Proposal #35: 6999-11-85, WISC 2025387
C WI Rapids, Wood Avenue
STH 13 Intersection Modification
LOC STR
Wood County

This is Addendum No. 01, which provides for the following:

ADDENDUM NO. 01

6999-11-85

Addendum No. 01
ID 6999-11-85
Added Sheet 16A
March 3, 2025

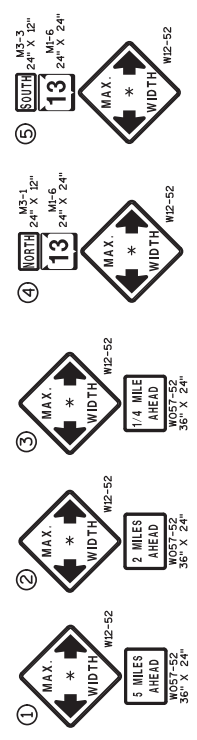
Added Plan Sheets	
Plan Sheet	Plan Sheet Title (brief description of why sheet was added)
16A	Added width restriction signing sheet.
50A	Added "Advanced Width Restriction Signing" standard detail drawing.

- * STAGE 1, PHASE 1: MAX. WIDTH = 12' (NORTHBOUND ONLY; NO WIDTH RESTRICTION SOUTHBOUND)
- * STAGE 1, PHASE 2: MAX. WIDTH = 12' (SOUTHBOUND ONLY; NO WIDTH RESTRICTION NORTHBOUND)
- * STAGE 2: MAX. WIDTH = 13'

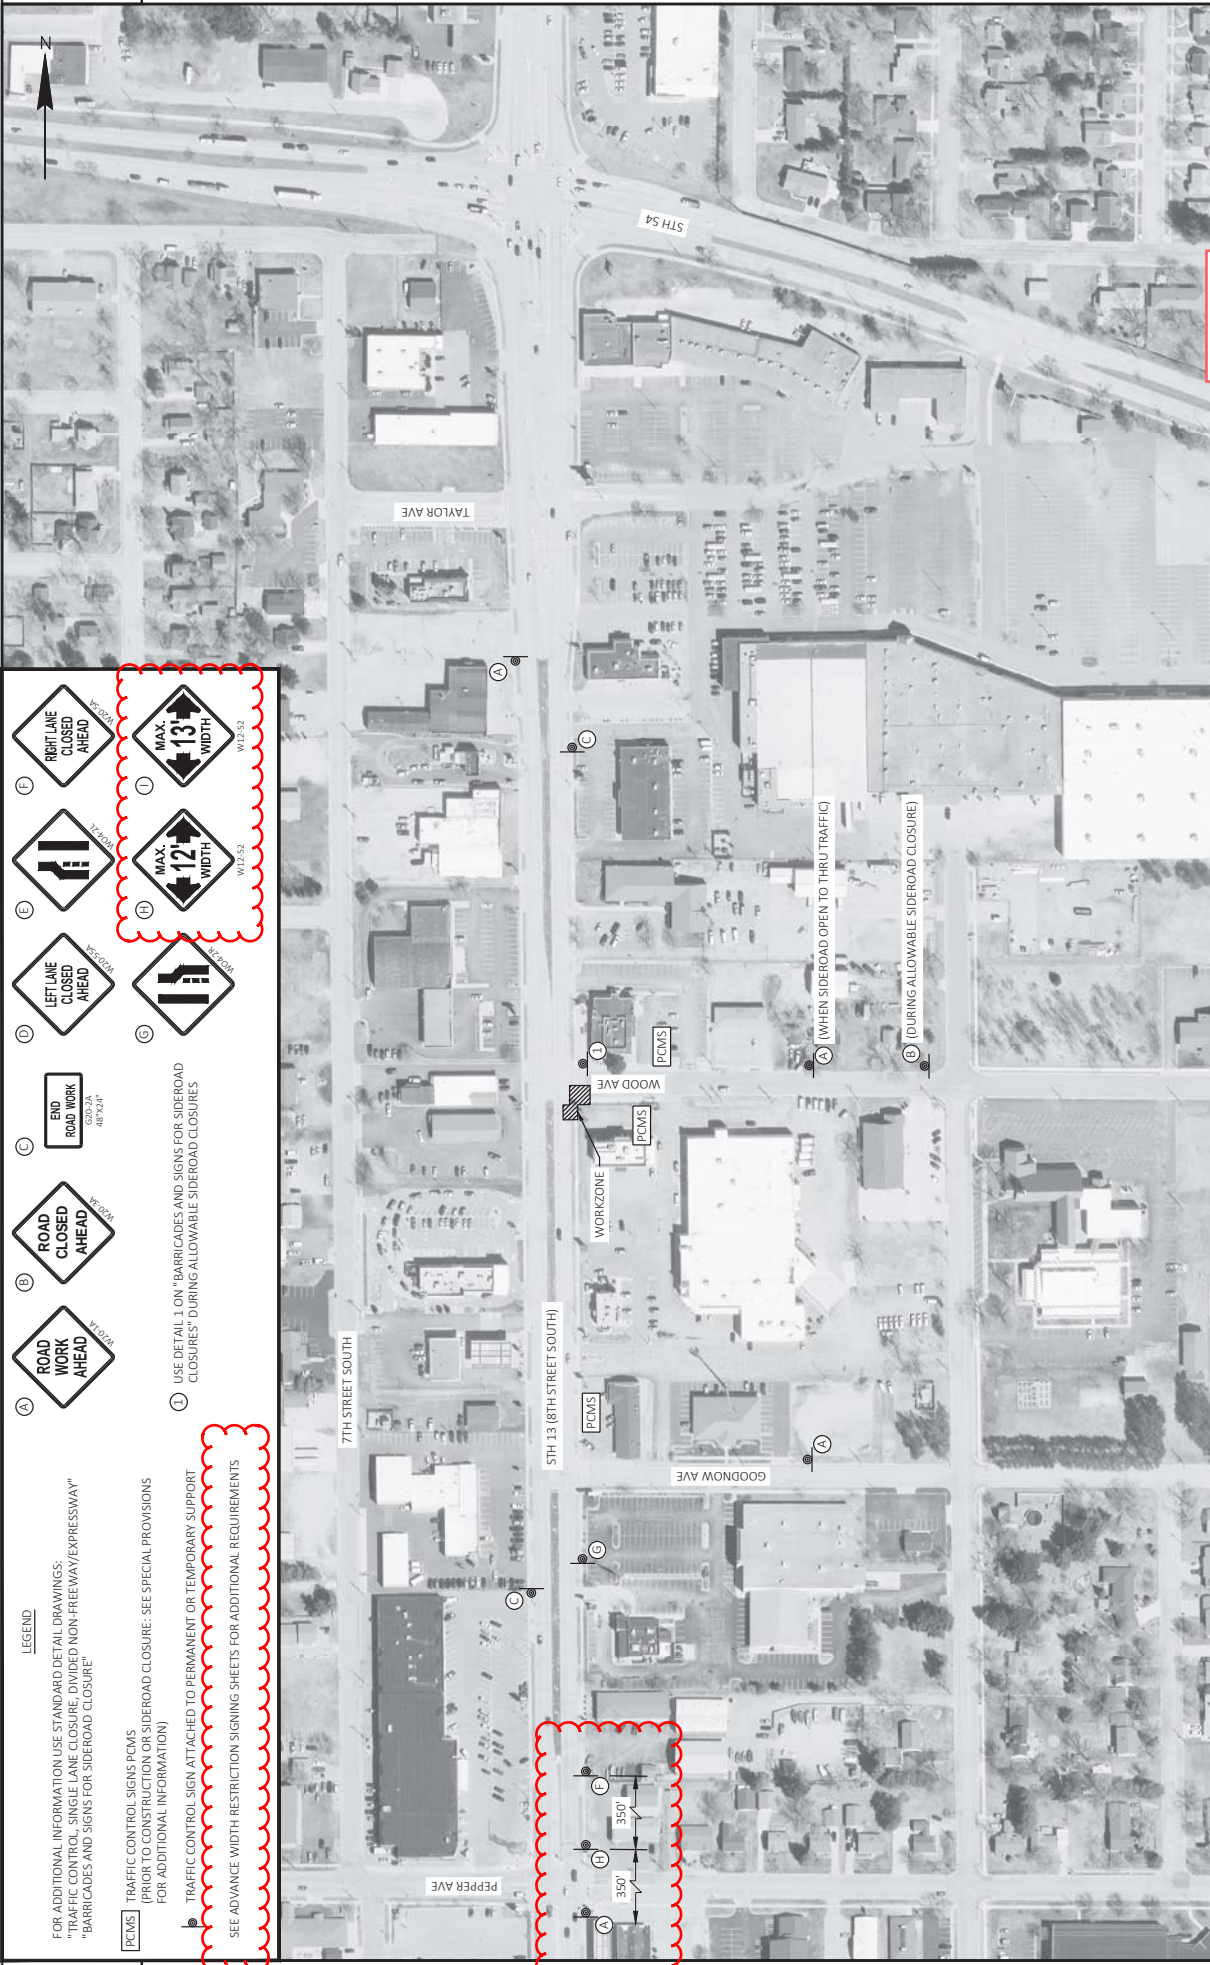
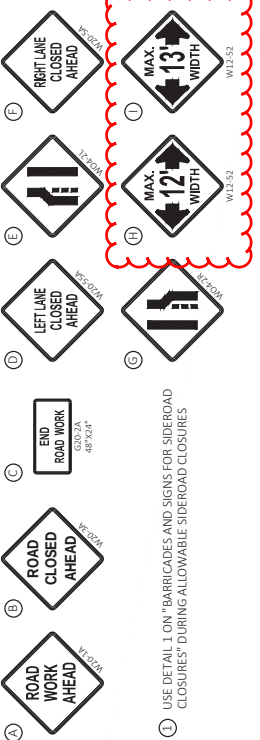
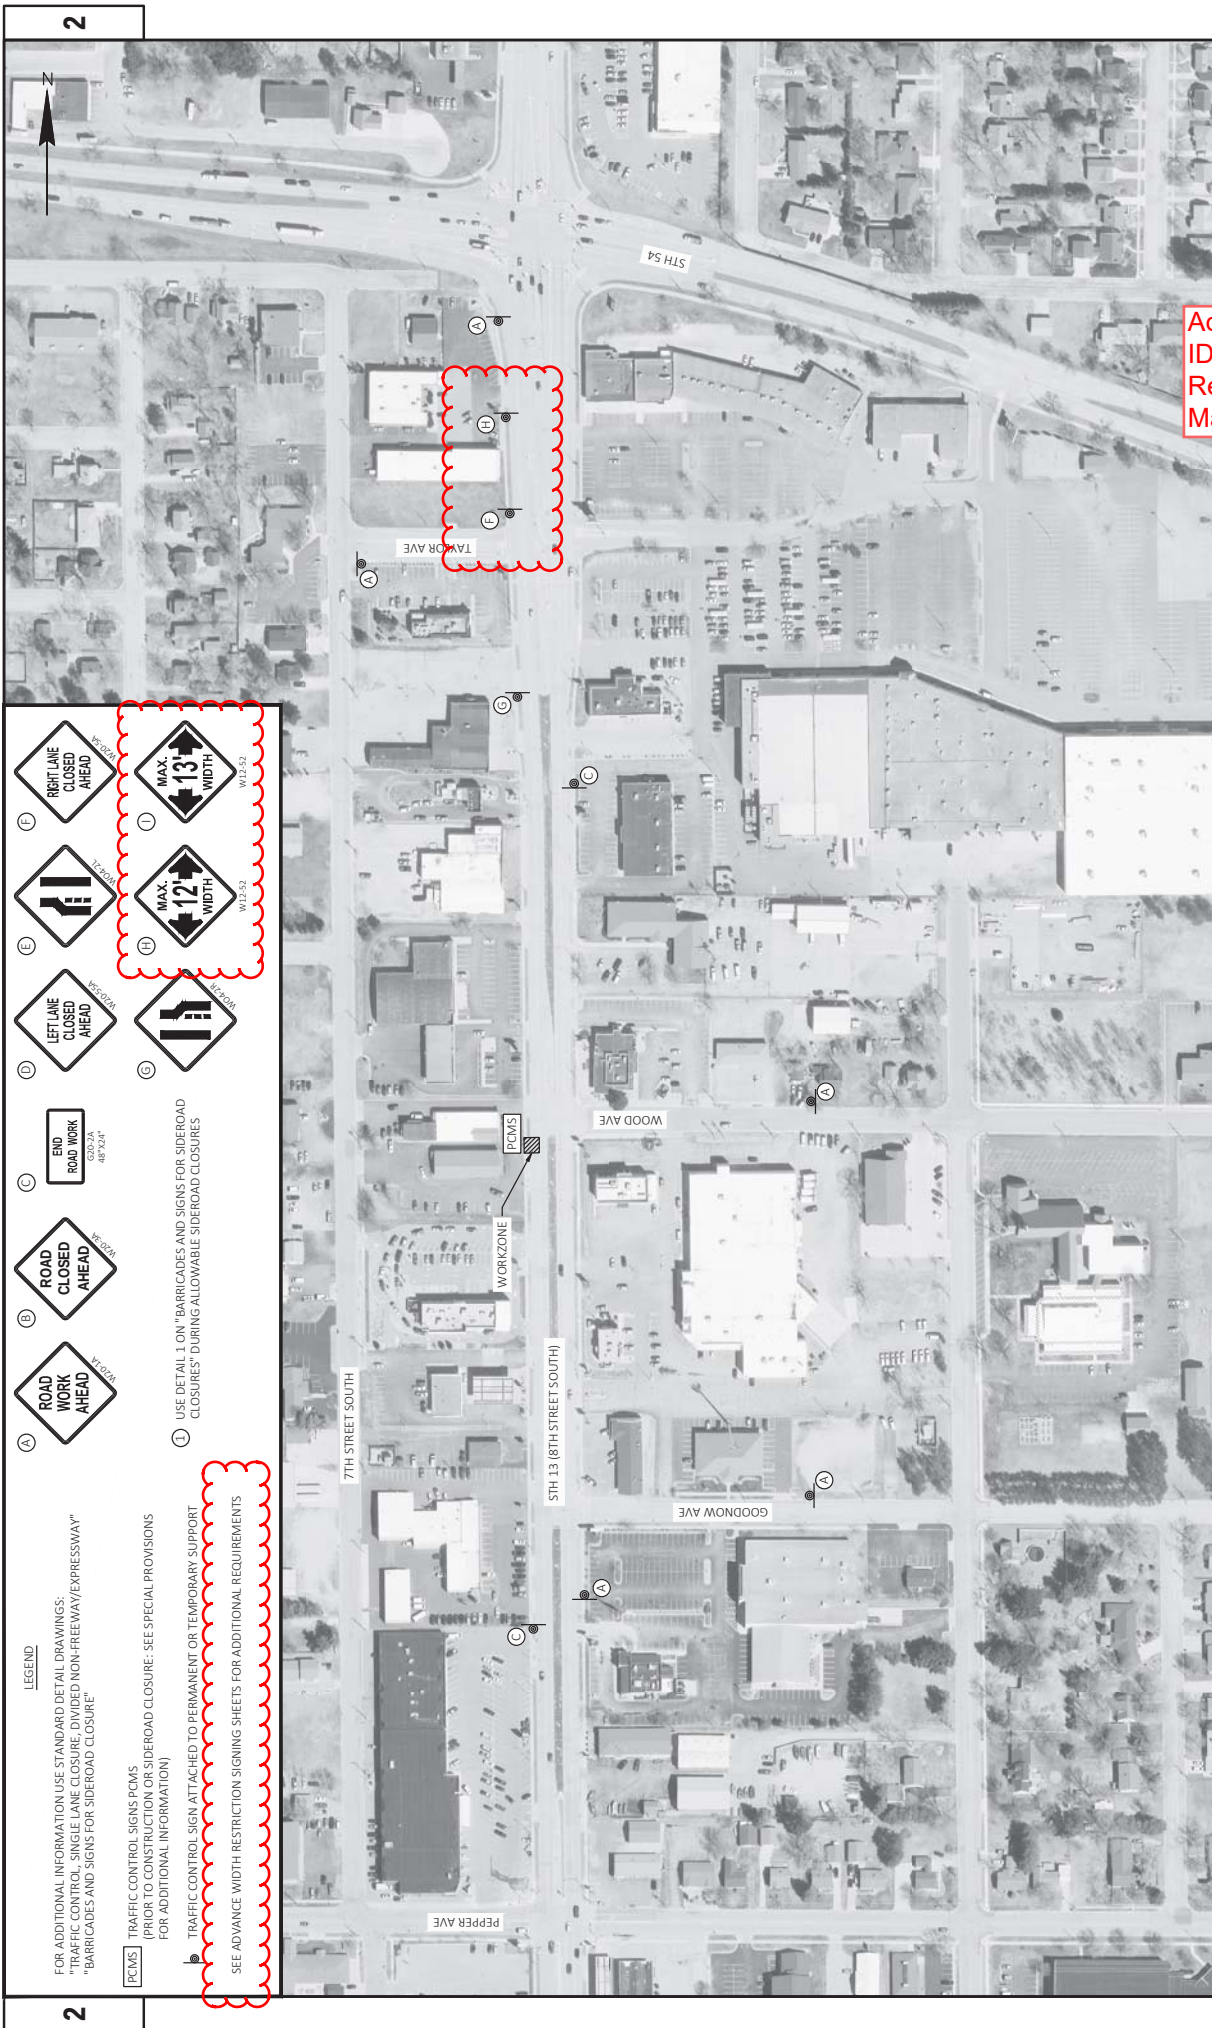
Revised Plan Sheets	
Plan Sheet	Plan Sheet Title (brief description of changes to sheet)
17-19	Revisions to include width restriction signing.
30	Revisions to Traffic Control Signs quantity.

- (A) ROAD WORK AHEAD
- (B) ROAD CLOSED AHEAD
- (C) END ROAD WORK
- (D) LEFT LANE CLOSED AHEAD
- (E) RIGHT LANE CLOSED AHEAD
- (F) MAX. 13' WIDTH
- (G) MAX. 12' WIDTH
- (H) MAX. 13' WIDTH
- (I) MAX. 12' WIDTH

Addendum No. 01
ID 6999-11-85
Revised Sheet 18
March 3, 2025

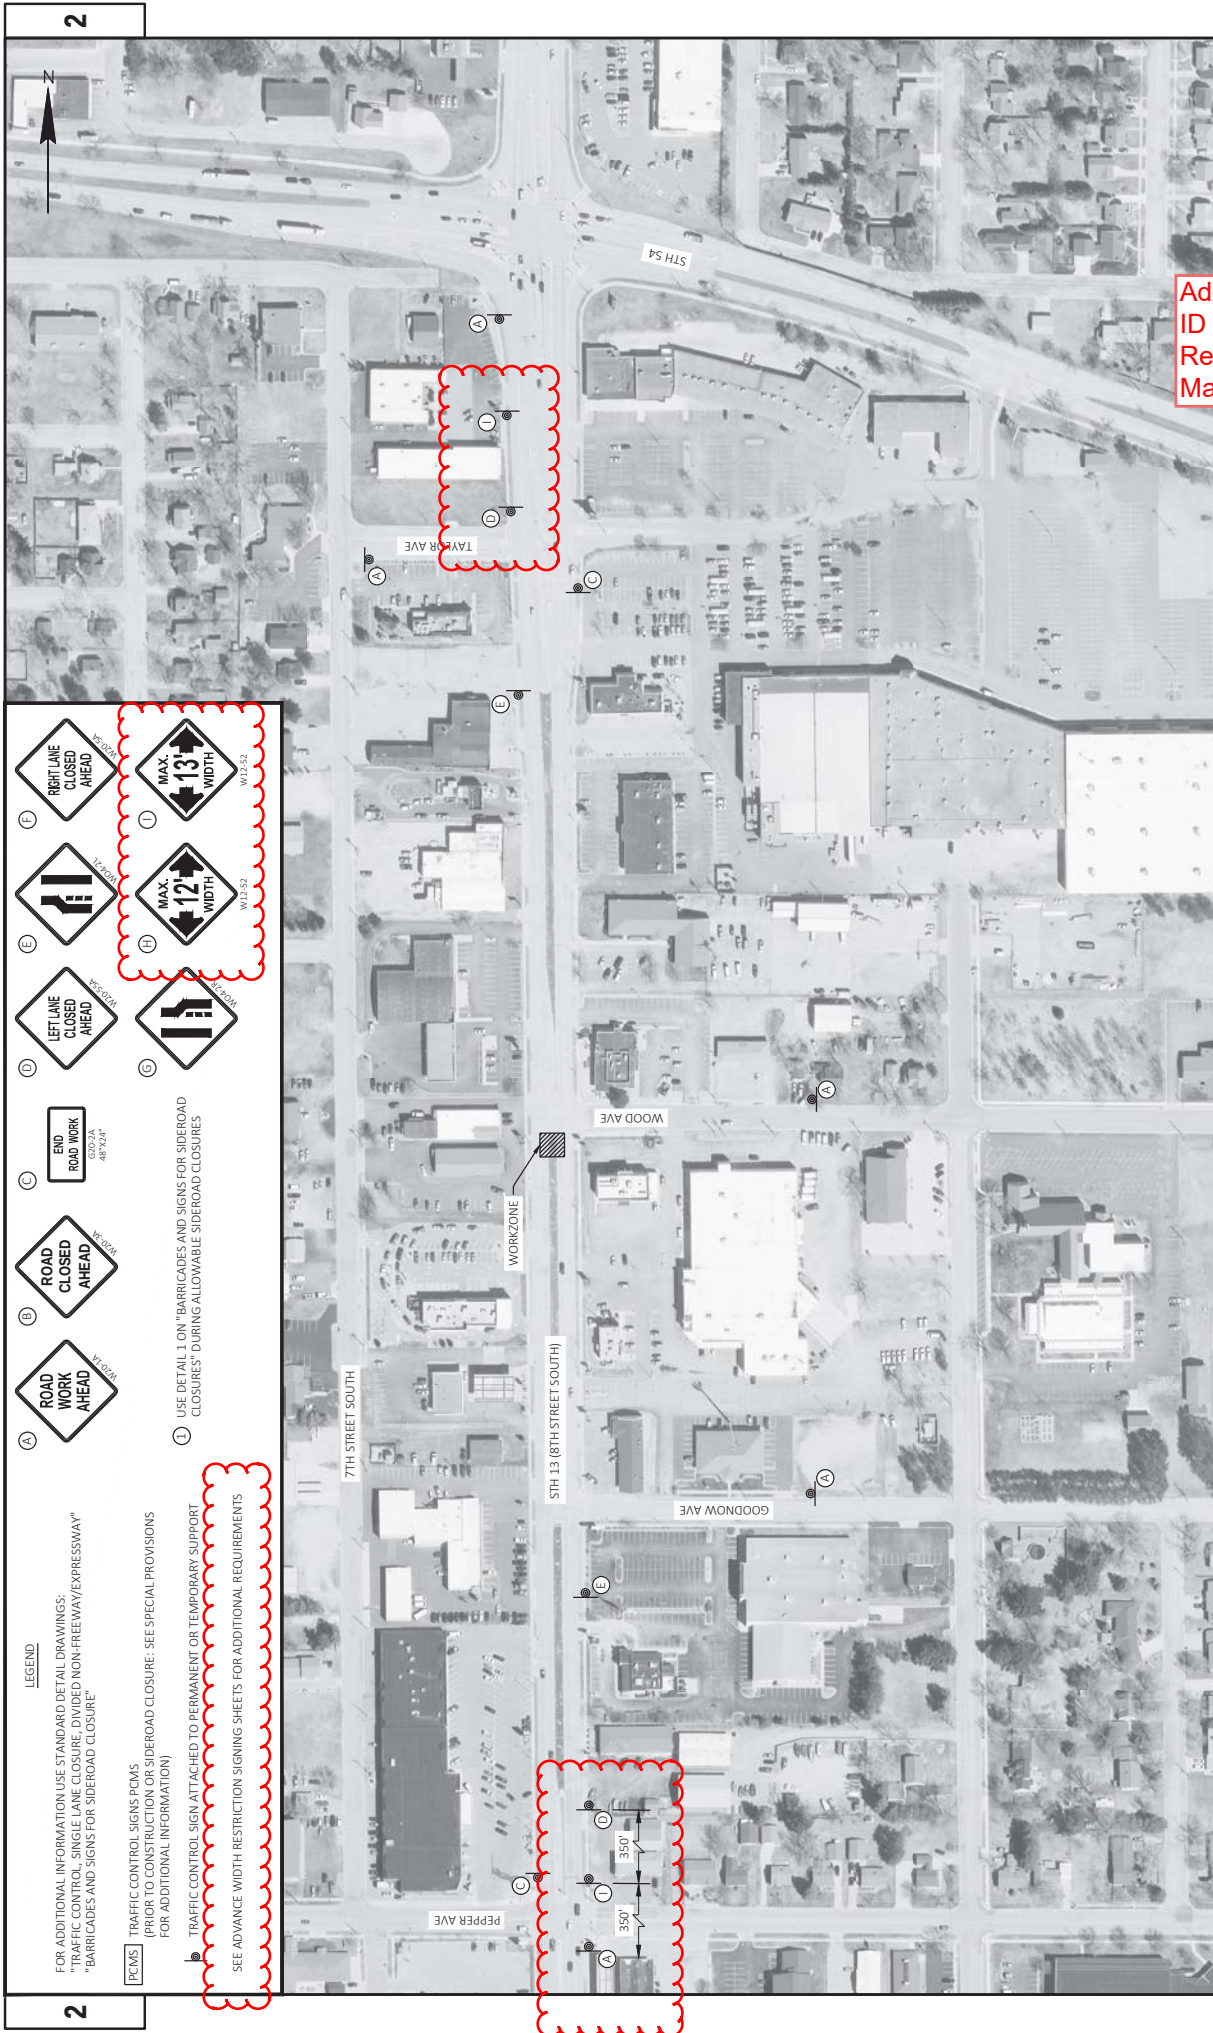
SEE ADVANCE WIDTH RESTRICTION SIGNING SHEETS FOR ADDITIONAL REQUIREMENTS
